SUBJECT: SEABROOK STATION, UNIT NO. 1 – ISSUANCE OF AMENDMENT NO. 168
RE: CHANGING TIME DELAY SETPOINTS FOR DEGRADED VOLTAGE
RELAYS (EPID L-2020-LLA-0012)

SEABROOK STATION, UNIT NO. 1

Amendment No. 168
License No. NPF-86

SAFETY EVALUATION BY THE OFFICE OF NUCLEAR REACTOR REGULATION

The NRC staff's evaluation is summarized in the figure below.

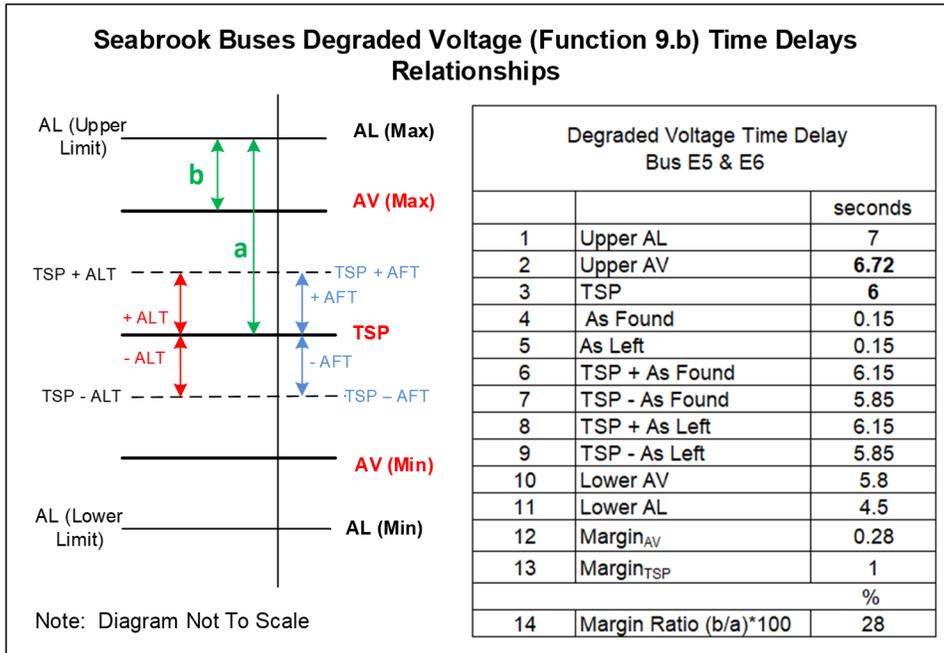
The NRC staff performed an independent confirmation evaluation of the following margins to determine whether there is a positive margin: between the AL and the TSP ($\text{Margin}_{\text{TSP}}$), and between the AL and the AV ($\text{Margin}_{\text{AV}}$).

$$\begin{aligned}\text{Margin}_{\text{AV}} (b) &= \text{AL} - \text{AV} \\ \text{Margin}_{\text{TSP}} (a) &= \text{AL} - \text{TSP}\end{aligned}$$

$$\text{Margin Ratio percent} = (b/a) \times 100 \text{ percent}$$

The NRC staff performed a confirmation evaluation of the $\text{Margin}_{\text{TSP}}$ and $\text{Margin}_{\text{AV}}$ of the Upper Level time delay only because the proposed maximum degraded voltage time delay relays that detect the degradation of the 4.16 kV buses E5 and E6 should be limited to protect the Class 1E loads from damaged or unavailability.

The NRC staff determined that:

- The TSP inclusive of its As-Found Tolerances, is less than the maximum AV and greater than the minimum AV to ensure that the trip signals will be initiated before TSP reach the AV values.
- The margin ratio percentages between the TSP and AV margins are greater than 28 percent and are adequate. These margins ensure that the trip setpoints have been chosen to ensure that a trip or safety actuation will occur significantly before the measured process reaches the Upper Analytical Limits. The proposed AV setting is an automatic protective action that will correct the abnormal situation before a safety limit is exceeded.
- The proposed maximum/minimum AV is in the time delay setting range of 1.5 to 15 seconds of the Agastat 7012 PC timing relays to maintain these variables and systems within prescribed operating ranges.

Based on the above discussion, the NRC staff finds that the proposed AV of the degraded voltage time delay settings (TSP and AV for the Functional Unit 9.b in TS Table 3.3-4) is consistent with RG 1.105 and satisfies the requirements of 10 CFR 50.36(c)(1)(ii)(A) and GDC 13. Therefore, the proposed TSP (≤ 6 seconds) and AV (≤ 6.72 seconds) of time delay relay settings are acceptable.
